Re: Off-site Groundwater Monitoring Program Reports
Naval Weapons Industrial Reserve Plant/
Northrop Grumman Corporation Facilities
Bethpage, New York
Site Nos. 1-30-003A and 1-30-003B
D&B 1883

MEMORANDUM

SUBJECT: Off-site Groundwater Monitoring Program
Naval Weapons Industrial Reserve Plant, Bethpage, New York
D&B No. 1883

ANALYTICAL RESULTS FOR VPB-44

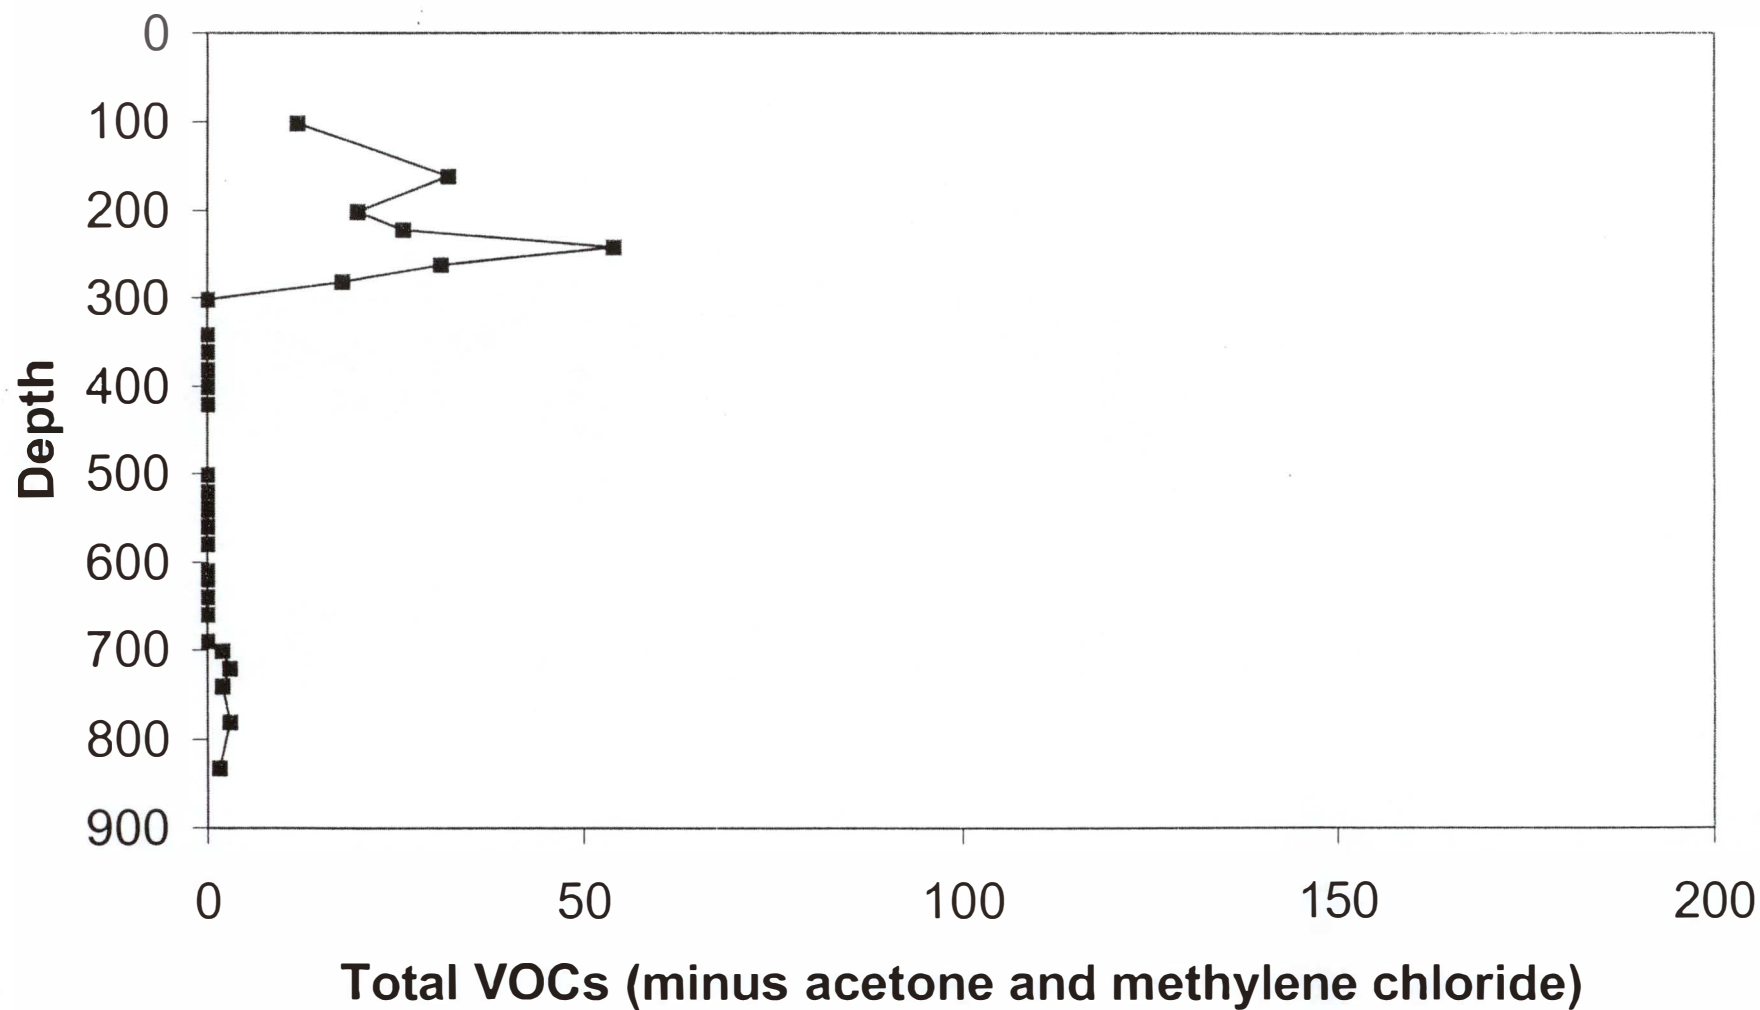
The MWD well field nearest to the identified contamination is the Northwest Well Field (Well No. 4 and Well No. 5), located approximately 9,000 feet south-southeast (downgradient) of VPB-50 and approximately 9,500 feet south of VPB-44 (at least 8,000 feet south of the presently modeled plume limit). The maximum total VOC concentrations (excluding acetone and methylene chloride) detected in VPB-44 and VPB-50 were 54 micrograms per liter (ug/l)

and 13 ug/l, respectively. Chlorinated VOCs, including 1,1-dichloroethane (1,1-DCA), 1,1-dichloroethene (1,1-DCE), 1,1,1-trichloroethane (1,1,1-TCA) and/or trichloroethene (TCE), were detected at concentrations exceeding NYSDEC Class GA groundwater standards at depths to 283 feet below ground surface in VPB-44. In VPB-50, 1,1-DCA, 1,1-DCE, 1,1,1-TCA and toluene were detected at concentrations at or below NYSDEC Class GA groundwater standards at depths to 151 feet below ground surface. VOCs were not detected in samples collected between 300 feet and 700 feet below ground surface in VPB-44 and between 200 feet and 800 feet in VPB-50. Below these depths, the detected contamination in both VPBs was MTBE and/or toluene at concentrations up to 3 ug/l each (total VOC concentrations were up to 3 ug/l). Based on these results, the groundwater sampling activities conducted to date in the area north of the Northwest Well Field have not defined the downgradient extent of the VOC contamination. Since, according to the MWD, no VOCs have been detected in either of the Northwest Well Field wells during the past two years, the plume has not yet reached this well field.

The gamma logs for VPB-44 and VPB-50 indicate clay or silty clay layers at depths of 298 to 310 feet, 438 to 442 feet and 590 to 605 feet below ground surface in VPB-44 and at depths of 320 to 327 feet, 415 to 435 feet and 455 to 461 feet below ground surface in VPB-50. While the continuity of the clay layers is unknown, they may serve to at least locally impede the vertical migration of contaminants.

ANALYTICAL RESULTS FOR VPB-45

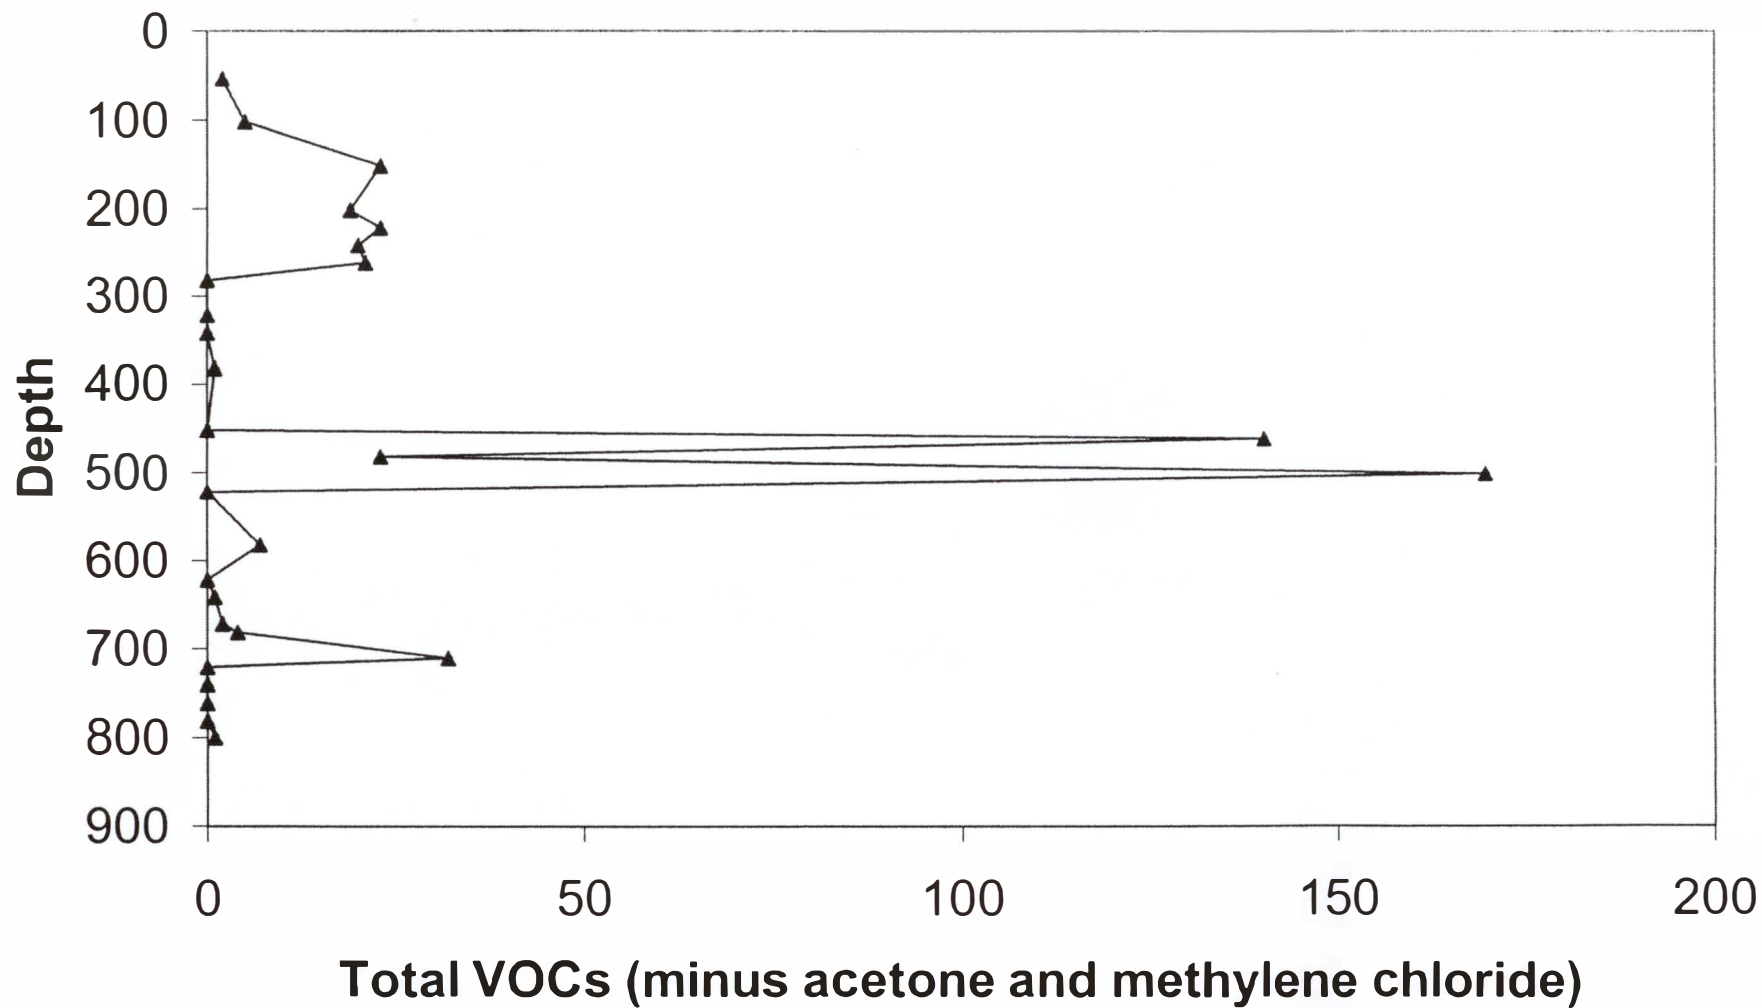
VPB-43 (2 ug/l at 801 to 802 feet). According to the report for the Southern Area, the significant concentrations of toluene (23 ug/l to 170 ug/l) detected in the three samples collected between 460 feet and 500 feet below ground surface in VPB-45 were attributed (by Tetra Tech NUS) to contamination of the sampling equipment. However, other toluene detections in deeper samples from these borings (1 ug/l to 32 ug/l in VPB-45 at 53 to 54 feet and various depths between 580 feet and 801 feet, and five detections of 1 ug/l to 4 ug/l at depths of 281 feet to 662 feet VPB-43) are reported as environmental contamination, which suggests the possibility of regional toluene contamination.

PUBLIC WATER SUPPLY WELL LOCATIONS AND VERTICAL PROFILE BORING LOCATIONS AND RESULTS

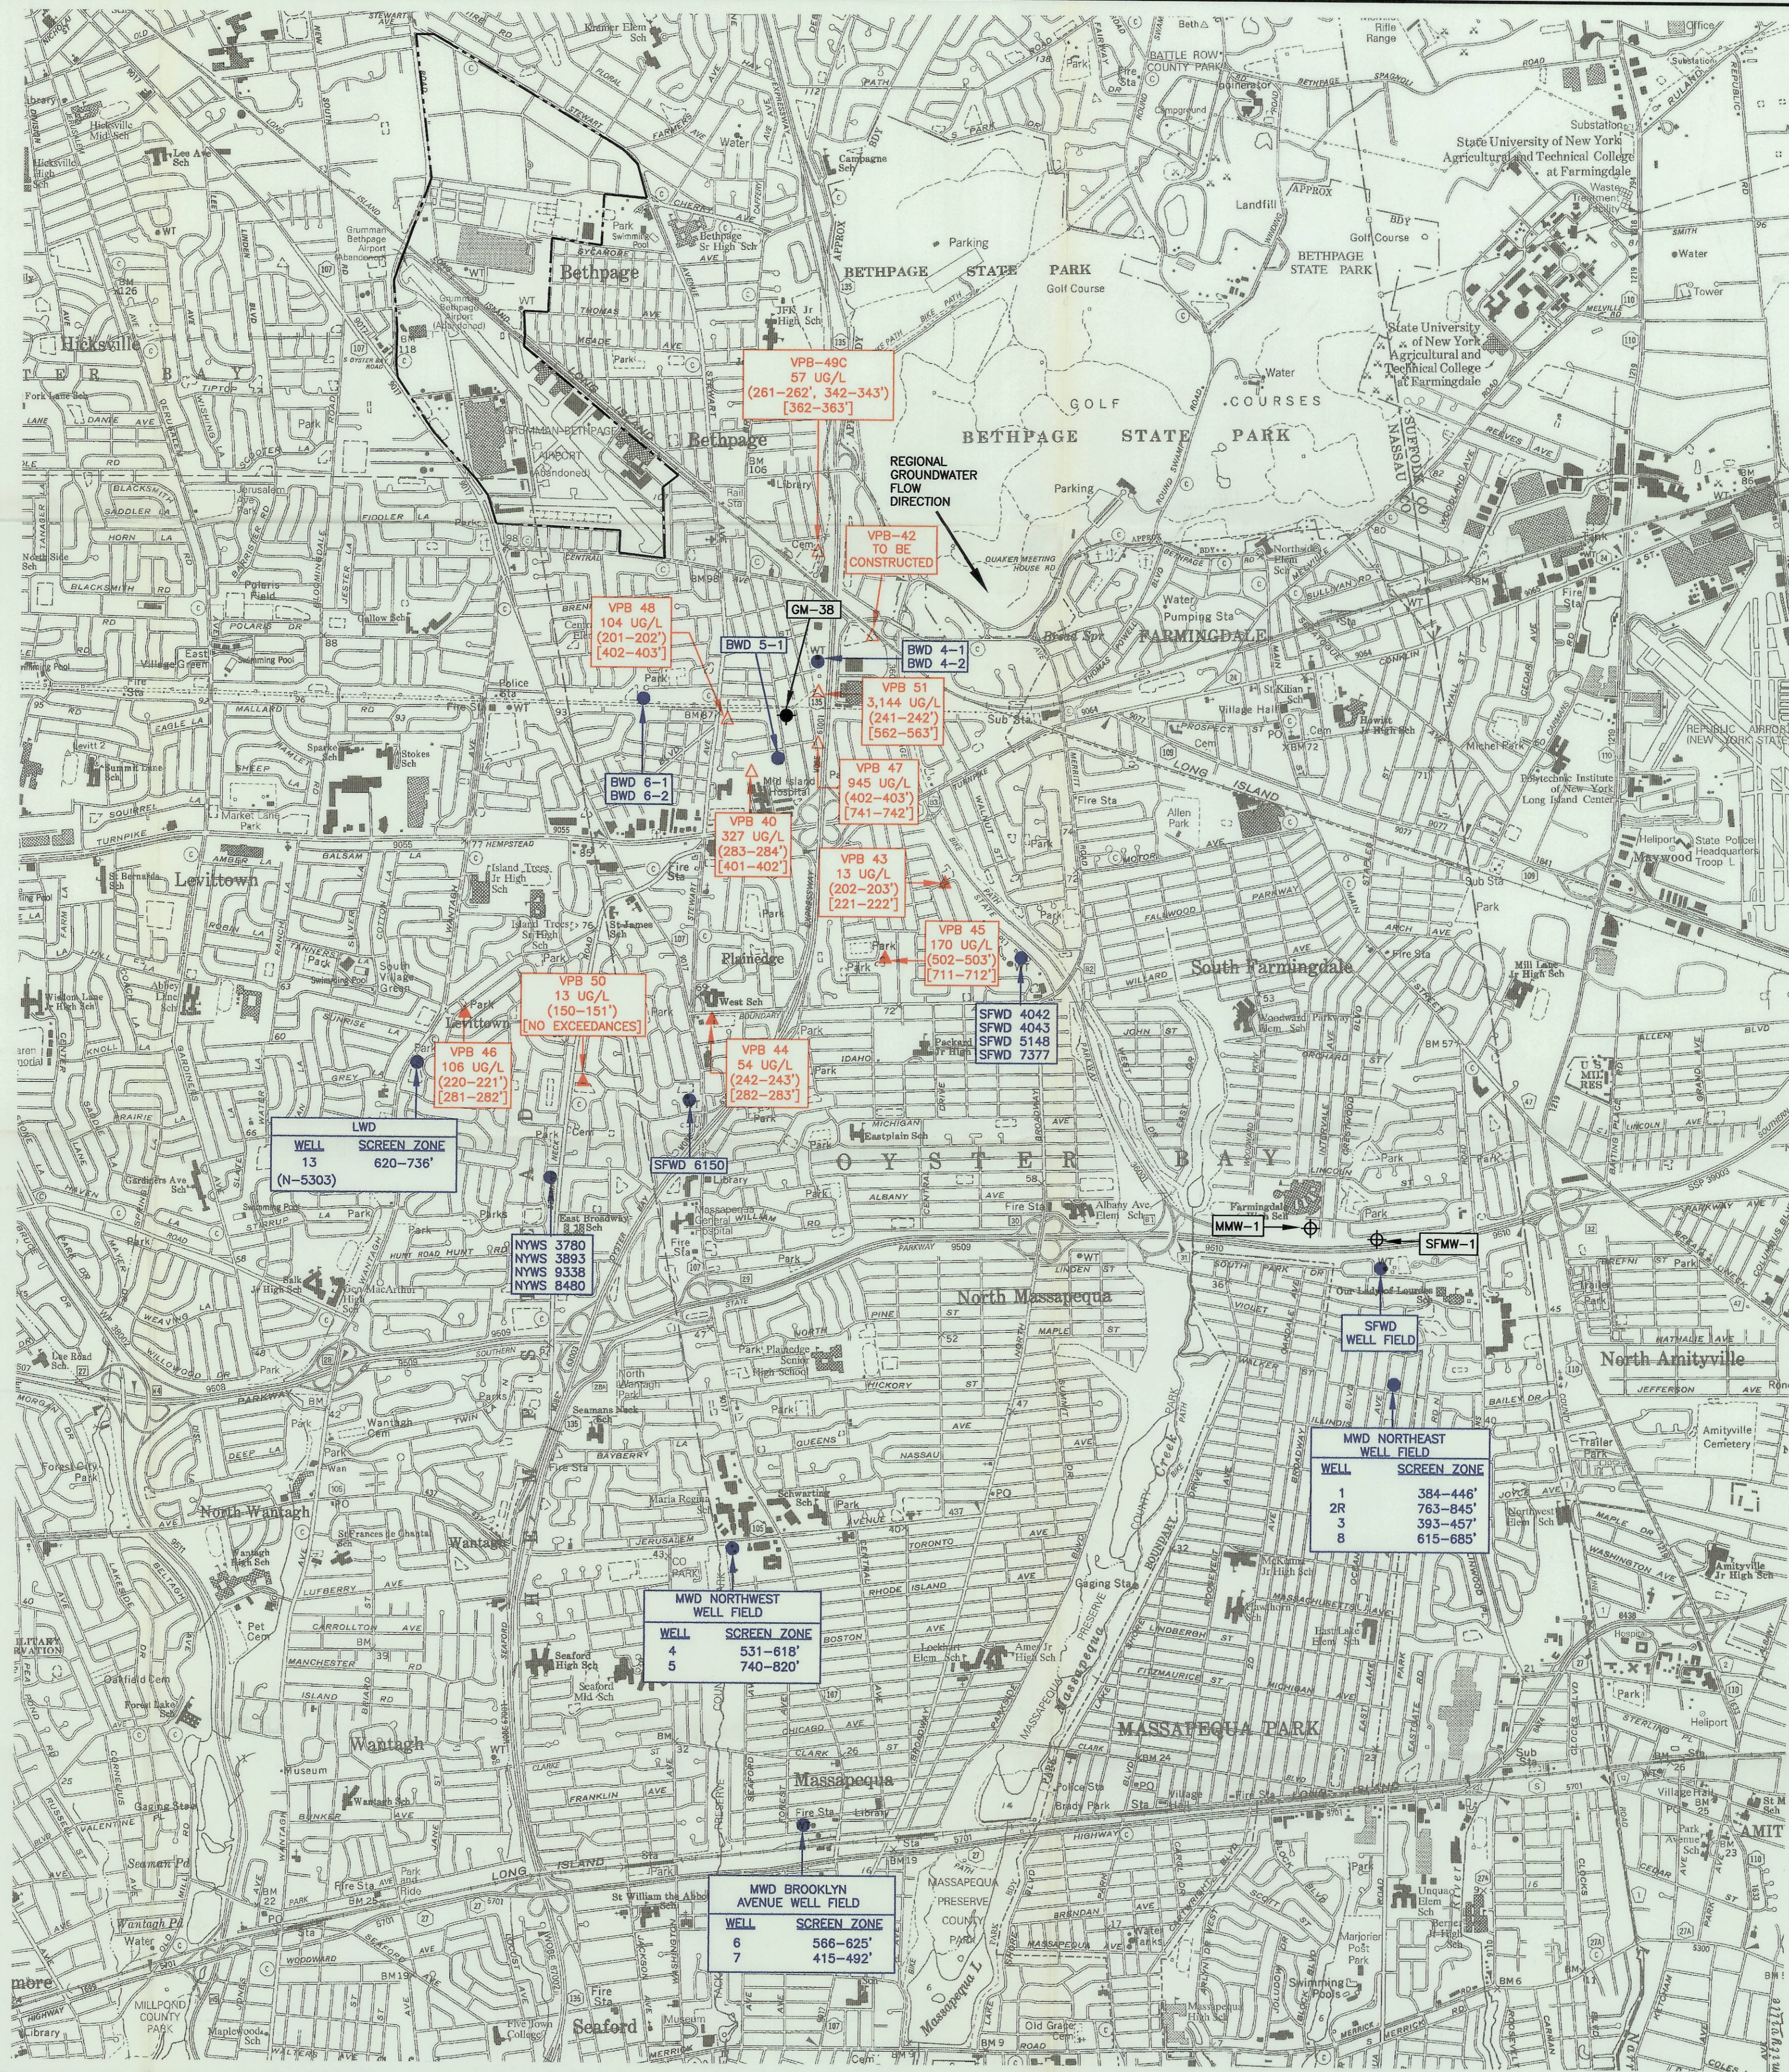
The off-site groundwater investigation was conducted to evaluate groundwater quality in two areas, the GM-38 Area and the Southern Area (south of Hempstead Turnpike), using vertical profile borings (VPBs). Four VPBs (VPB-40, VPB-47, VPB-48 and VPB-51) were constructed to delineate the extent of groundwater contaminated by volatile organic compounds (VOCs) in the GM-38 Area, an area of significantly elevated concentrations of VOCs (maximum total VOCs of 3,144 micrograms per liter (ug/l) in VPB-51) located north of Hempstead Turnpike and west of the Seaford-Oyster Bay Expressway. Five VPBs (VPB-43, VPB-44, VPB-45, VPB-46 and VPB-50) were constructed in the Southern Area (south of Hempstead Turnpike) to establish the southern/downgradient extent of VOC contamination between Hempstead Turnpike and downgradient public water supply wells. The locations of public water supply well fields, the vertical profile borings and GM-38 are shown on Figure 1.

The five VPBs in the Southern Area were drilled upgradient of the public water supply wells for the South Farmingdale Water District, Town of Hempstead Levittown Water District, New York Water Service and Massapequa Water District (MWD) (see Figure 1). Note that the following discussion of results excludes the common laboratory contaminants methylene chloride and acetone, which were detected in individual samples from the Southern Area VPBs at concentrations up to 11 ug/l and 78 ug/l, respectively. Graphs showing the total VOC concentrations versus depth for these VPBs are attached. The maximum total VOC concentration for each VPB and the associated sample depth, as well as the maximum sample depth at which VOCs were detected at concentrations above New York State Department of Environmental Conservation (NYSDEC) Class GA groundwater standards, are shown on Figure 1.

VPB-43 and VPB-45 were constructed east of the Seaford-Oyster Bay Expressway, upgradient of South Farmingdale Water District (SFWD) well field containing wells N-4042, N-4043, N-5148 and N-7377 and the MWD Northeast Well Field (see Figure 1). Similar to VPB-44 and VPB-50, the sample results from VPB-43 and VPB-45 show chlorinated solvents (1,1-DCA, chloroform, 1,1-DCE, 1,1,1-TCA, TCE and/or tetrachloroethene (PCE)) at concentrations up to 10 ug/l each (total VOCs up to 23 ug/l) in samples collected from depths up to approximately 300 feet below ground surface. The only VOC detected in samples collected from deeper than 300 feet below ground surface in either boring was toluene, except for one detection of TCE in

As reported by ARCADIS Geraghty and Miller, groundwater modeling results to date show that the detectable concentrations of VOCs migrating from the NWIRP/NGC facility have reached the SFWD well field containing wells N-4042, N-4043, N-5148 and N-7377 (see Figure 1), although the depth of contamination is reported as above the screen zones of these wells. The MWD Northeast Well Field is located approximately 9,500 feet southeast of the SFWD wells. As shown on Figure 1, the easternmost VPBs constructed to date (VPB-49C, VPB-51, VPB-47 and VPB-43) all contained VOCs at concentrations exceeding NYSDEC Class GA groundwater standards, in some cases by orders of magnitude. This indicates that the eastern extent of the contamination has not been delineated. As a result, the potential threat to the Northeast Well Field cannot be evaluated at this time.

As shown on Figure 1, the westernmost VPB constructed as part of the Southern Area investigation was VPB-46. Chlorinated VOCs (1,1-DCA, 1,2-dichloroethane, 1,1-DCE, 1,2-dichloroethene, 1,1,1-TCA, TCE and/or PCE) were detected at individual concentrations up to 32 ug/l and total VOC concentrations up to 106 ug/l in samples collected from depths up to 300 feet. No VOCs were detected in any sample collected from deeper than 300 feet. These results show that the western and southern extent of contamination has not been determined in this area. Since the regional groundwater flow direction is toward the south-southeast, the detected VOCs could migrate toward the MWD Northwest Well Field.

Concentrations of VOCs exceeding Class GA groundwater standards were detected in all VPBs constructed in the Southern Area except one (VPB-50). Based on these results, the extent of VOC contamination in groundwater and threat to the MWD wells have not been defined. It is therefore recommended that additional VPBs be constructed so that potential impacts to downgradient public water supply wells can be evaluated. Additional VPBs should be constructed east of the Bethpage State Parkway to delineate the plume to the east and upgradient of the MWD Northeast Well Field. Also, additional VPBs should be constructed south of VPB-44, VPB-45 and VPB-46 to delineate the contamination to the south of these locations and upgradient of the MWD Northwest and Brooklyn Avenue Well Fields. These activities should be conducted prior to selection of locations and depths of outpost monitoring wells.
